Prepared for:
Macquarie University
Date:
25 September 2018

Response to Submissions

Macquarie University Central Courtyard Precinct

Above: Revised Design

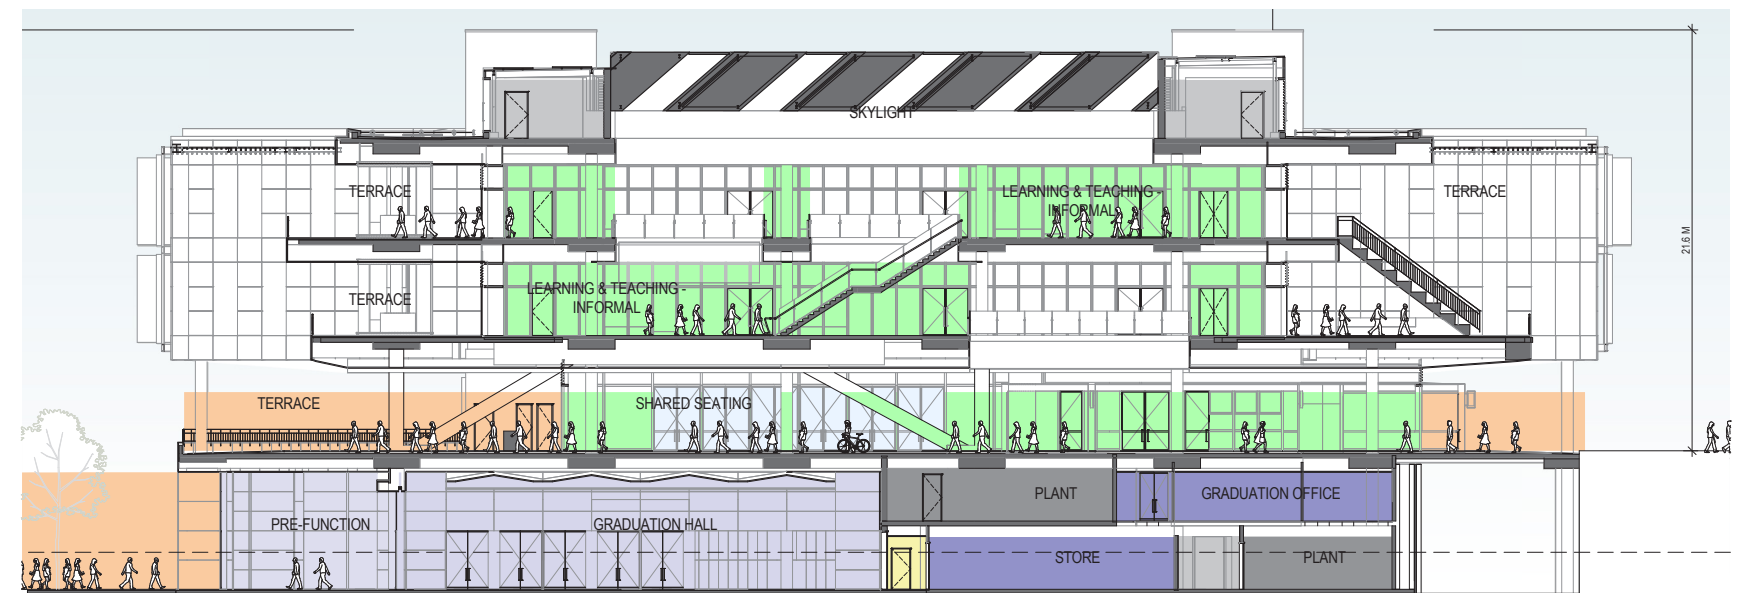
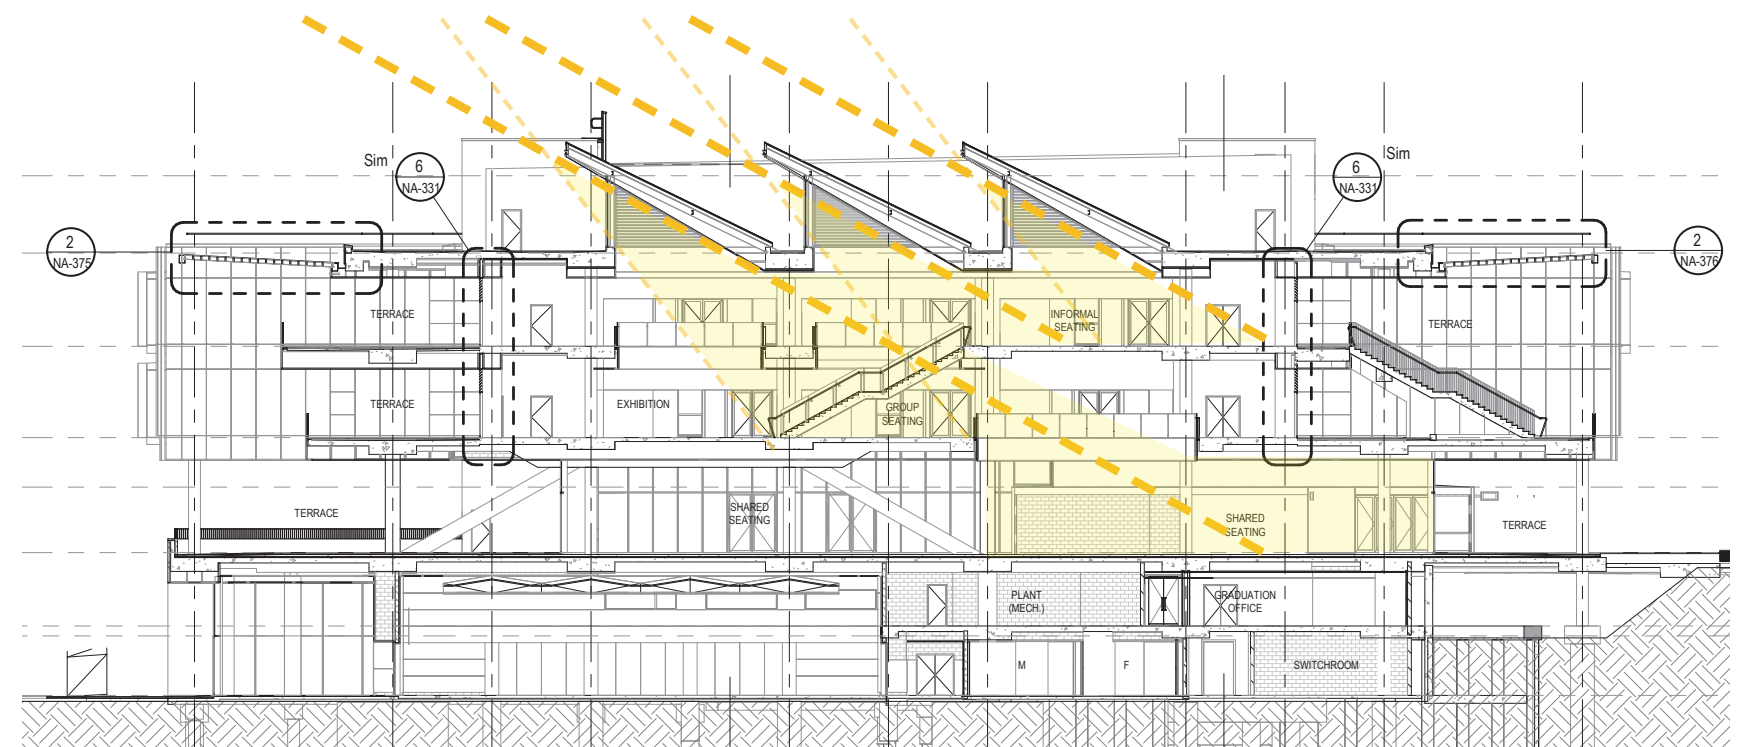
The proposed 1CC building brings additional natural light through an internal atrium but as the floor openings are not aligned the spatial impact of the atrium is compromised - as is the capacity to bring natural light into the building.

Subsequent to the SSDA submission design changes have been made. A large skylight has been designed with a northern orientation and angled to permit greater natural light penetration to the teaching levels. Interactions between the L01-L02 Learning & Teaching floors are facilitated via connecting stair voids. The spatial connection between Ground Level (food and beverage) and the Learning and Teaching levels is staggered to provide necessary acoustic separation.

Above: Diagram illustrating that 60% of the northern elevation at Courtyard Level is open to views.

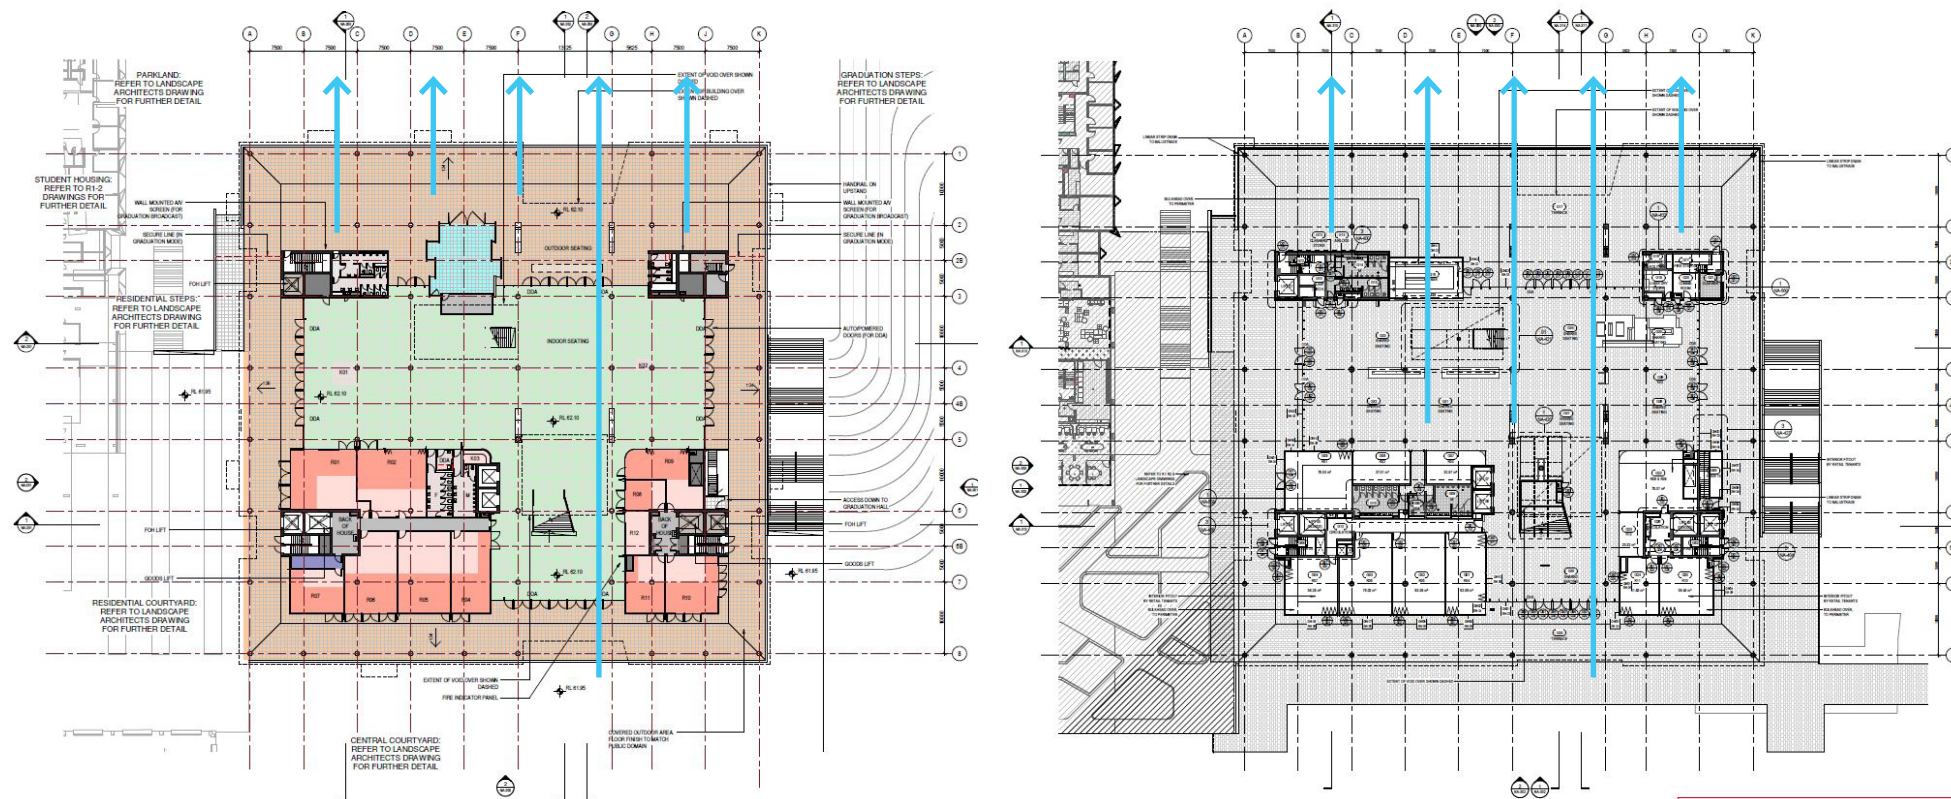
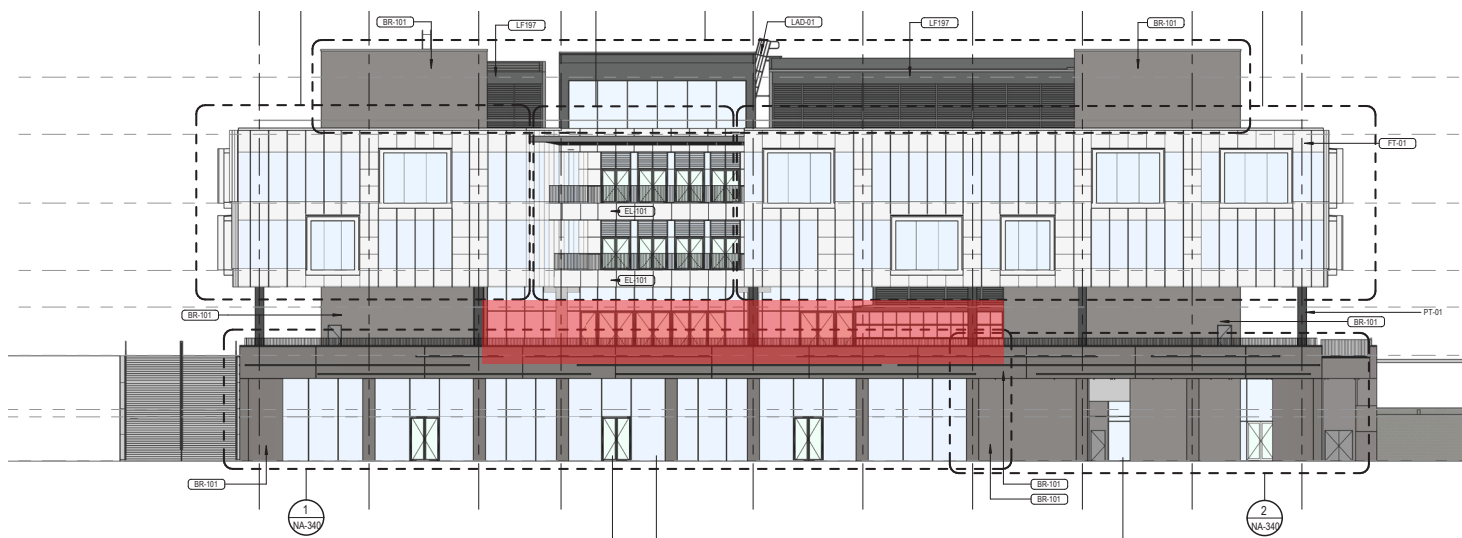
The ground level of the 1CC building is intended to open to the panoramic views north of the Academic Core. This view is obscured by the placement of stairs, lifts, amenities and a teaching area along most of the northern frontage. These could be reconfigured to capture a greater proportion of the view from within the building.

Teaching space has been removed from the Ground Level and increased transparency to northern parkland has been achieved. The U-Bar can be looked across. There are uninterrupted views from the terrace to the landscape.

We have studied the potential to reconfigure the ground level arrangement of the stairs, lifts, amenities and teaching areas to open up the view to the north from within the building however given the multiple competing functional and technical aspects it is assessed not be a viable option. The vertical stacking of services and egress routes associated these cores cannot be acceptably redesigned to open up one level of elevation of the five levels without causing significant impact upon those other levels.

Above: Revised Design

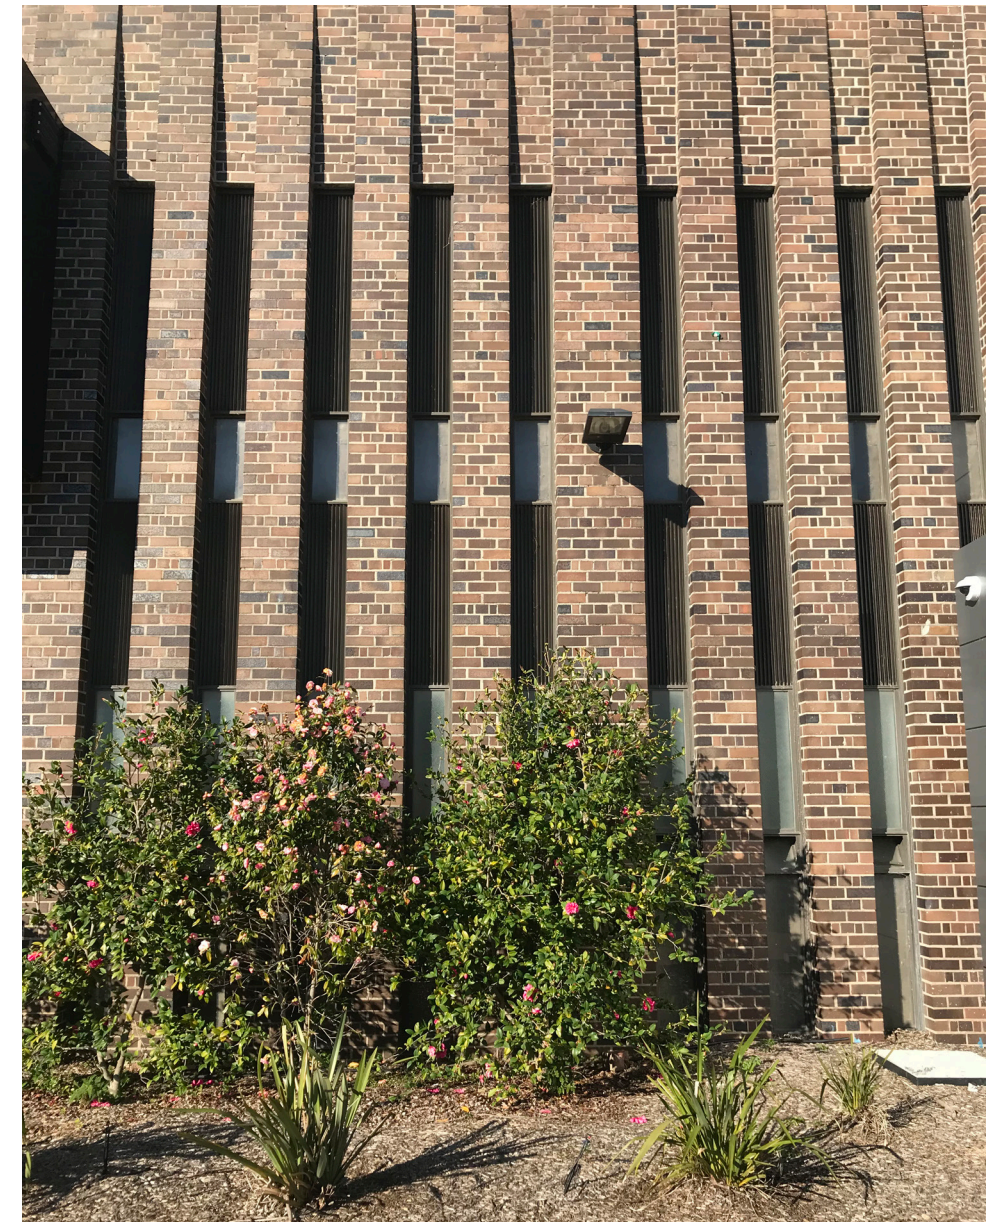
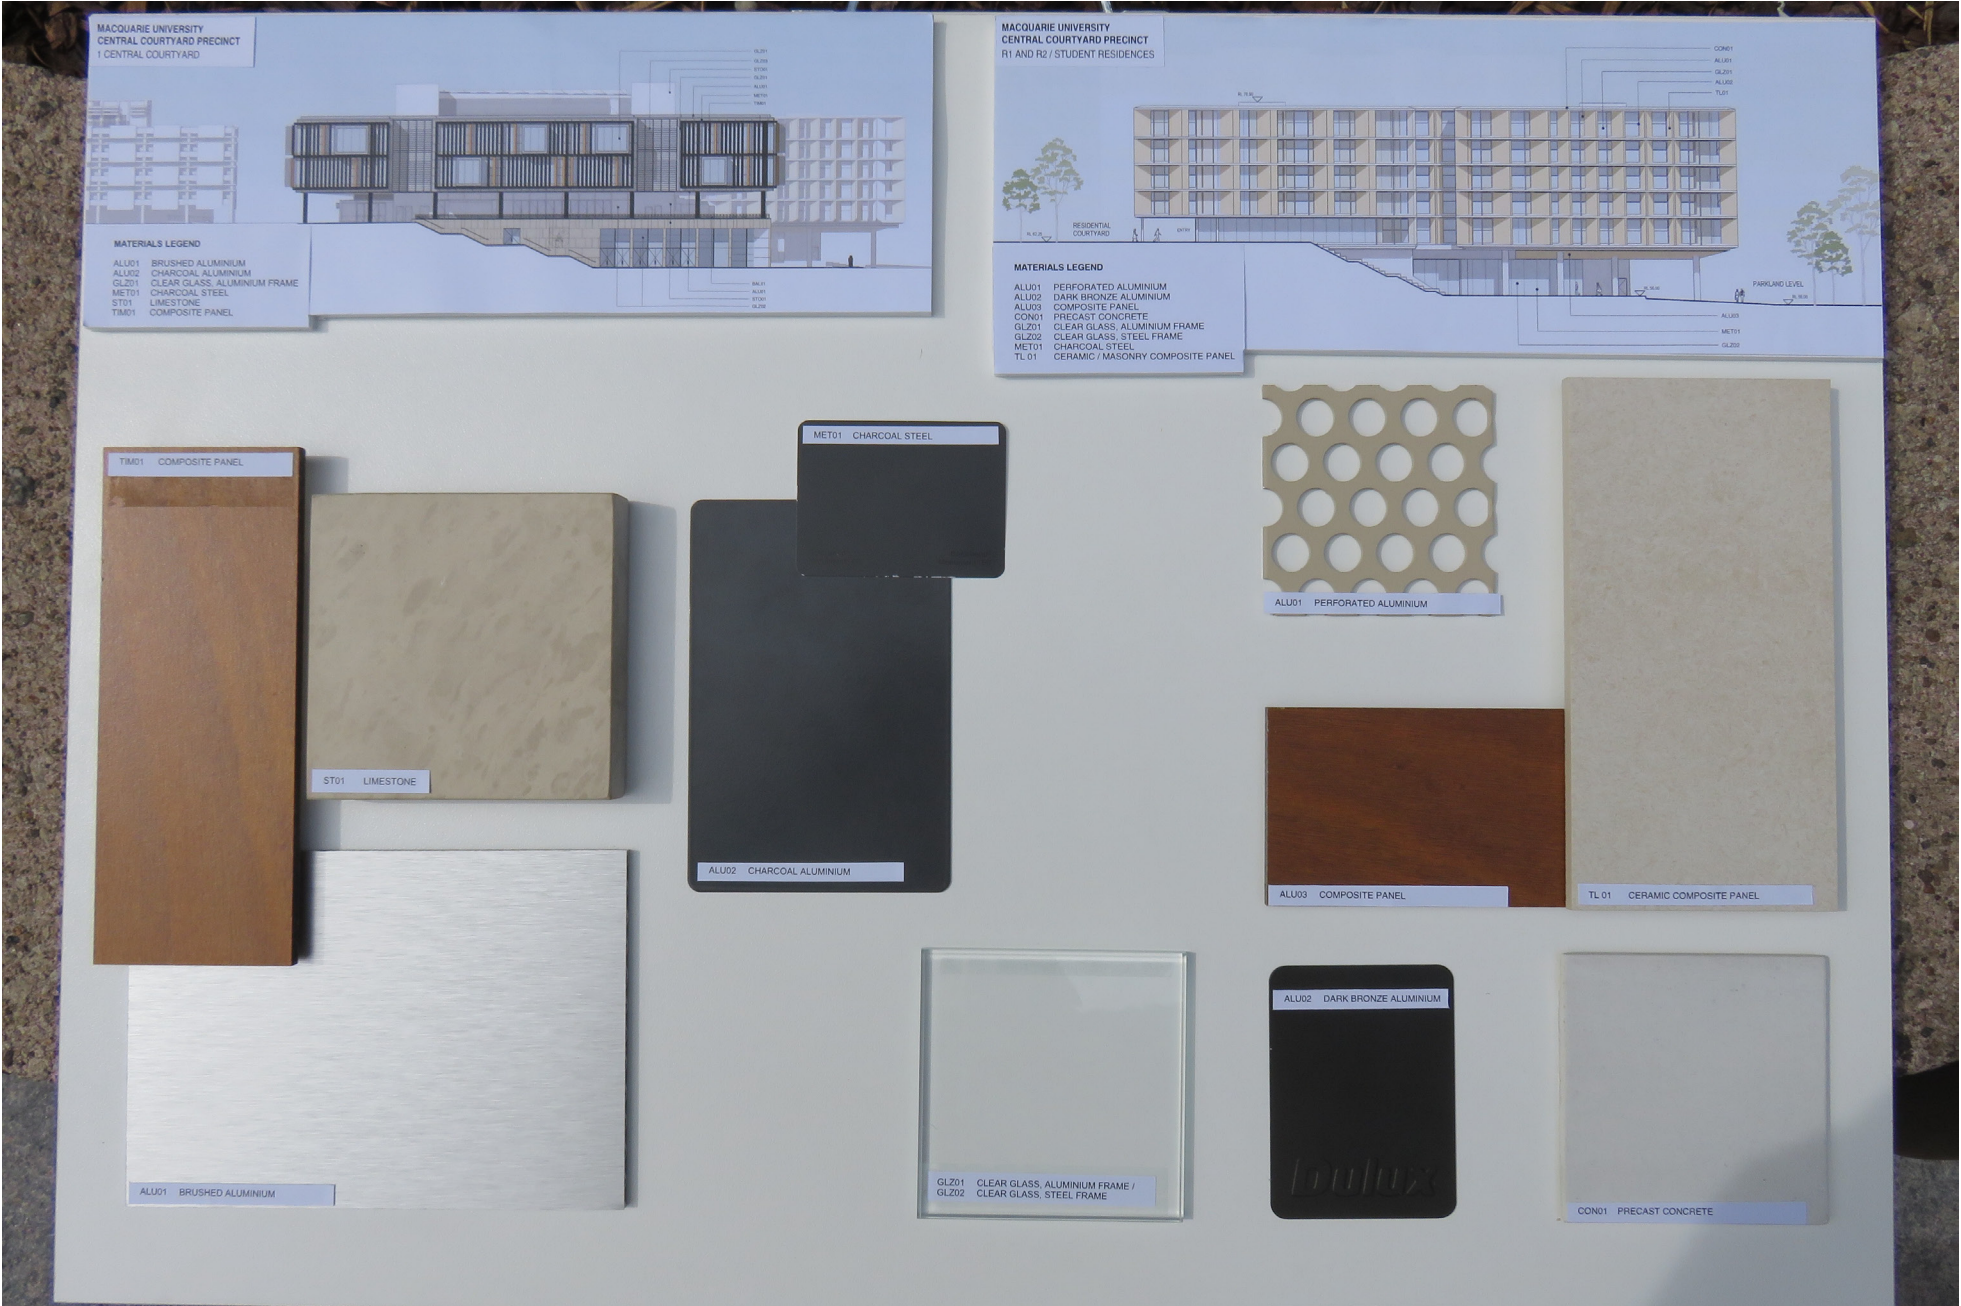
The campus is characterised by the textures of face brick and off form concrete (a legacy of the 'Brutalist style architecture'). The proposed buildings are not a comfortable fit, using contemporary finishes that are lightweight, metallic and reflective. We believe that more consideration of the architectural legacy should be applied to the design of replacement buildings, particularly in relation to articulation and materiality.

Since the SSDA, the external finishes of the 1CC building have been altered to replace the previously proposed limestone panels with dry-pressed bricks. This adjustment generates a positive relationship with the other Academic buildings on the Macquarie University campus that are similarly clad in brick.

The 1CC Building has had its materiality revised such that its lower level is proposed to be clad in dry-pressed bricks that establish a respectful relationship to the legacy of the campus's brick buildings - inclusive of the adjacent E7a and E7b buildings. The upper levels of 1CC are detailed with window boxes that generate a positive dialogue with the scale of the adjacent Peter Hall-designed C7a (old library) building and the nearby E8a Building. The silvery colour of the upper level cladding to the proposed 1CC Building is harmonious with the exposed grey concrete of the Brutalist palette in this precinct.
